Access Compliance Report

Public Rights-of-Way

(Curb Ramps)

Intersection ID: 31478	Main Street: ALSTON_HILL_DR	Cross Street: ELISE_MARIE_DR	Location:	N
ADA ID: BA9E94FCEA5A	Ramp Type: PerpDiag	Initial Pass/Fail: Fail	Overall Compliance: No	Severity Score: 8.75
Codes/Mitigation Info/Possible Solution		Field Measurements/Component Compliance

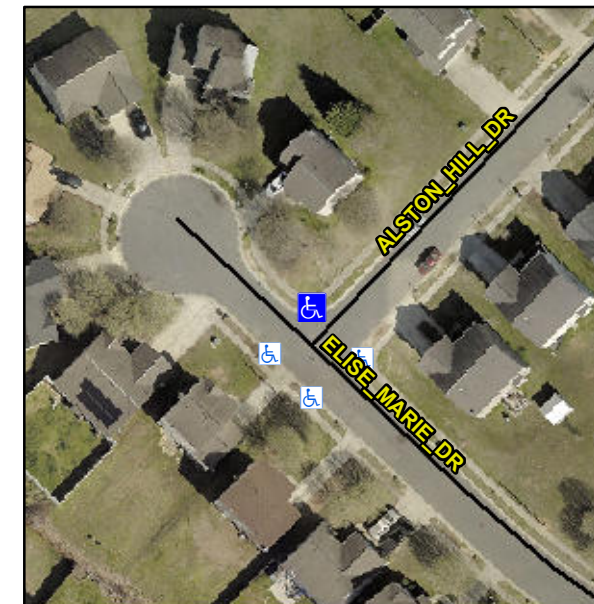
Not Found, R304.5.1

Compliance	Description	Data	Compliance	Description	Data
N/A	Ramp Length (in)	47.0	Yes	Ramp Slope (%)	7.5
No	Ramp Width (in)	47.0	Yes	Ramp XSlope (%)	0.2
N/A	Flare Type LT	N/A	N/A	Flare Type RT	N/A
N/A	Flare Slope LT (%)	N/A	N/A	Flare Slope RT (%)	N/A
N/A	Flare Traversable LT?	N/A	N/A	Flare Traversable RT?	N/A
N/A	Landing Length (in)	N/A	N/A	DWS Provided?	N/A
N/A	Landing Width (in)	N/A	N/A	DWS Contrast?	N/A
N/A	Landing Slope (%)	N/A	N/A	DWS Length (in)	N/A
N/A	Landing X Slope (%)	N/A	N/A	DWS Full Width?	N/A
N/A	Landing Curb? (Y/N)	N/A	N/A	DWS Offset (in)	N/A
N/A	Shared Landing?	N/A			
N/A	Gutter Ponding?	Yes	N/A	Gutter Slope (%)	N/A
N/A	Gutter Lip Ht (in)	N/A	N/A	Gutter X Slope (%)	N/A
N/A	Painted X Walk1?	No	N/A	Painted X Walk2?	No
	X Walk 1 Direction	To SW		X Walk 2 Direction	To SE
N/A	X Walk 1 Width (in)	N/A	N/A	X Walk 2 Width (in)	N/A
	X Walk 1 Slope (%)	2.3		X Walk 2 Slope (%)	4.8
	X Walk 1 X Slope (%)	4.7		X Walk 2 X Slope (%)	2.2

Remove & Replace Curb Ramp With Two New Directional Ramps or Equivalent.
